Subject: Adjustment Screws Removal

Overview

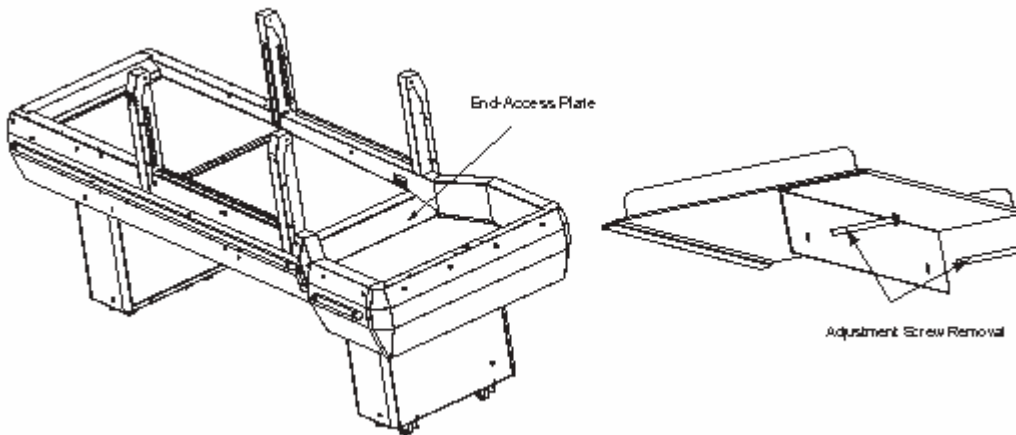
There are two adjustment screws installed under the End Access Plate, within the SBU unit, which are not used and can cause potential damage to the belt if not removed.

The adjustment screws can damage the belt if the plate is installed incorrectly.

Simply remove and discard the two screws if present.

Ensure that the adjustment screws are not installed on the underside of the End-Access Plate. If the adjustment screws are present, **remove and discard them**. These screws can damage the belt if the plate is installed incorrectly.
